# 62-F-216-C  
W.P. # 148-62  
PROP. CROSSING  
HWY. # 101,  
LITTLE PINE  
LAKE

W. A. TROW & ASSOC. LTD.  
FOUNDATION INVESTIGATION  
**LITTLE PINE LAKE & PROPOSED  
HWY. NO. 101 REV. LINE CROSSING**

Mr. A. M. Toye,  
Bridge Engineer.  
Materials & Research Division,  
(Foundation Section)

Re: Proposed Crossing, Hwy. No. 101,  
Little Pine Lake, District No. 18,  
W.F. 148-62.

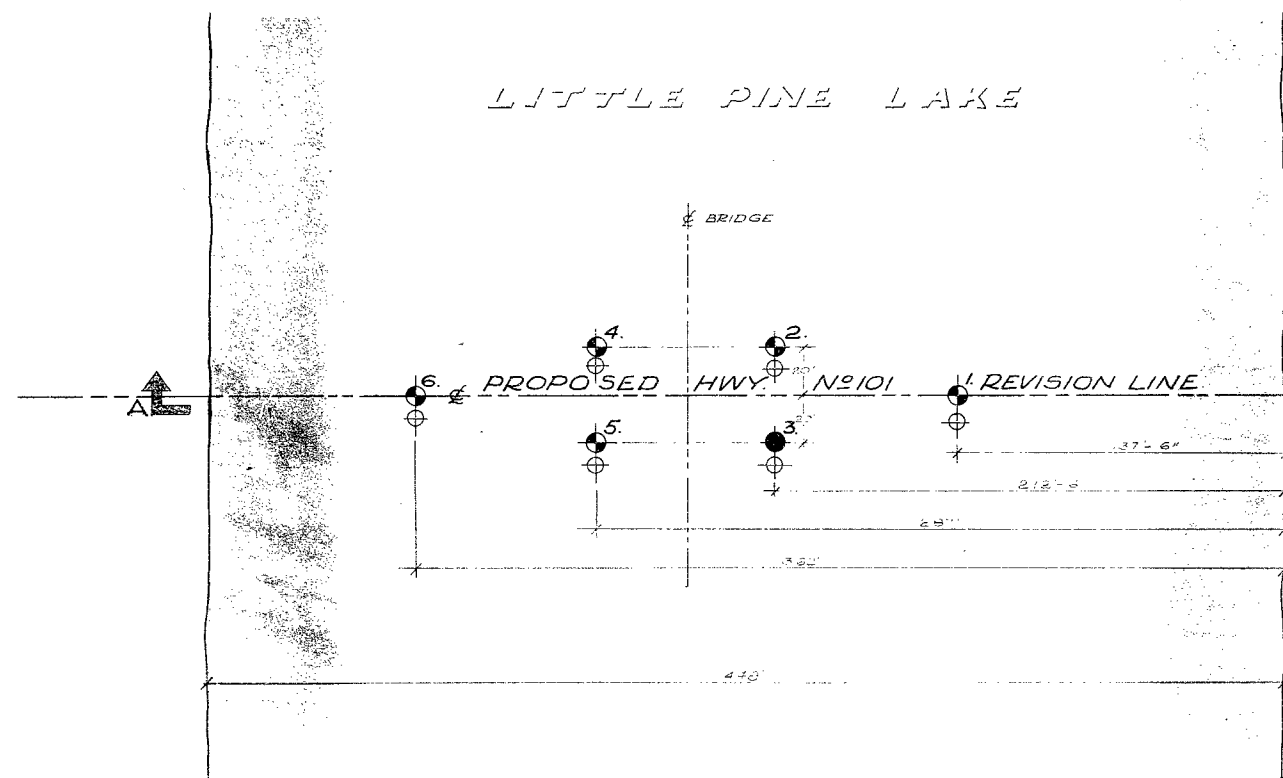
Attached please find one print of plan D-5167-1 for the above crossing. The structure has been designed in accordance with the recommendations contained in the Foundation Report submitted by Mr. W.A. Trow & Associates.

The pile test recommended should not be necessary as the design load in this structure is about 11 tons/pile.
